SUBJECT: NuScale Power, LLC Updates to Final Safety Analysis Report, Section 1.6, "Materials Referenced," Section 3.6, "Protection Against Dynamic Effects Associated with Postulated Rupture of Piping," and the "Pipe Rupture Hazards Analysis," TR-0818-61384

Enclosure 1 to this letter provides a mark-up of the FSAR pages incorporating revisions to Section 1.6 "Materials Referenced" and Section 3.6, "Protection Against Dynamic Effects Associated with Postulated Rupture of Piping" in redline/strikeout format. NuScale will include these changes as part of a future revision to the NuScale Design Certification Application.

Enclosures 2 and 3 provide a mark-up of the "Pipe Rupture Hazards Analysis" (PRHA) technical report (TR) pages incorporating consistency corrections (as required) in redline/strikeout format. NuScale will include these changes as part of a future revision to the NuScale PRHA technical report. Enclosure 2 contains the proprietary version of the report titled "Pipe Rupture Hazards Analysis," Revision 1. NuScale requests that the proprietary version be withheld from public disclosure in accordance with the requirements of 10 CFR § 2.390. The enclosed affidavit (Enclosure

Figure 3.6-1: Flowchart of methodology for evaluation of line breaks **Not Used**

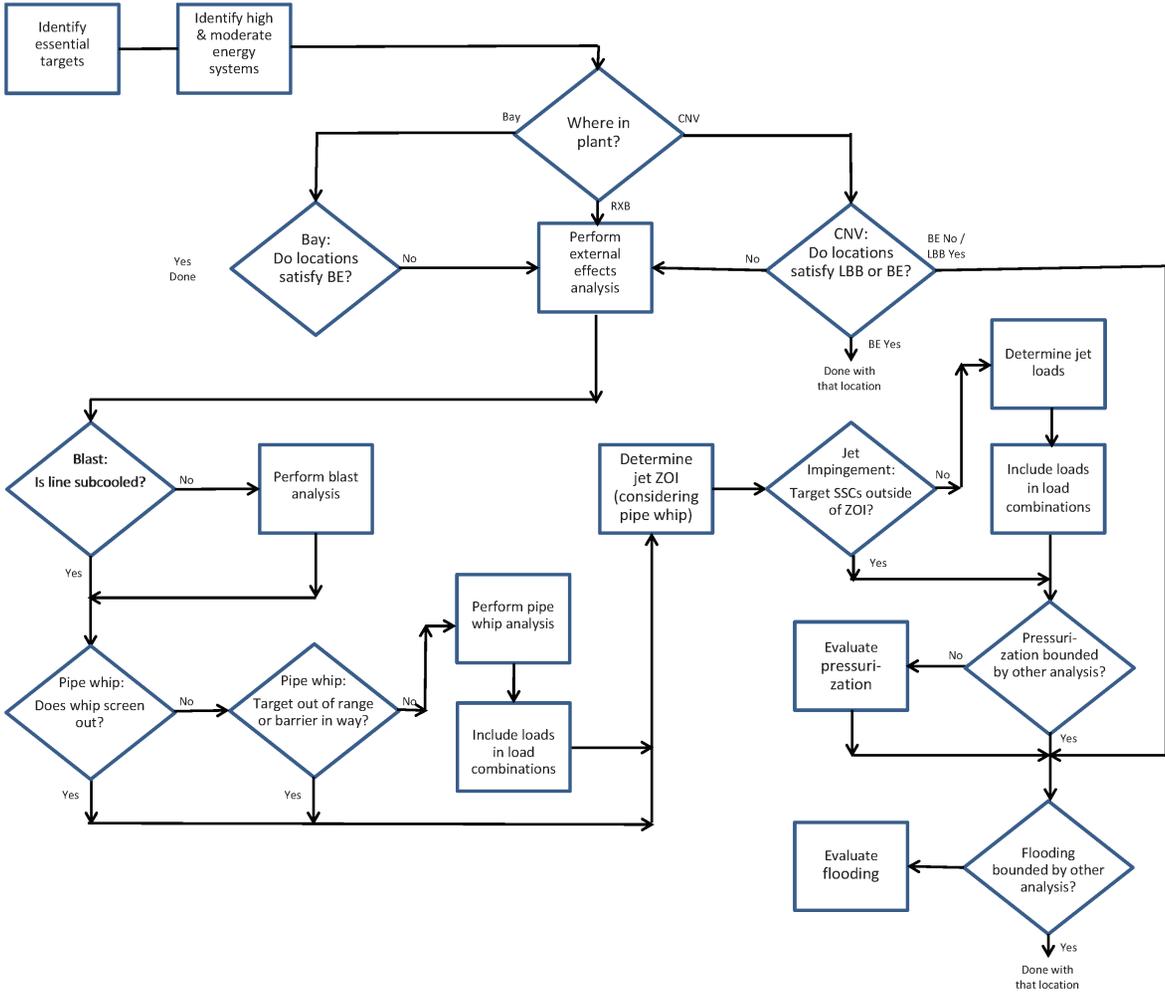
This section describes the design bases and measures needed to protect safety-related and essential systems and components inside and outside containment against the effects of postulated pipe rupture. [Figure 3.6-1 is a flowchart depicting the steps in the process for evaluation of potential line breaks. The NuScale methodology applicable to identification and assessment of pipe rupture hazards addresses determination of postulated rupture locations, characteristics of ruptures, and assessment of the possible dynamic and external effects of ruptures.](#) Details of the analyses are provided in the Pipe Rupture Hazards Analysis Technical Report (Reference 3.6-21).
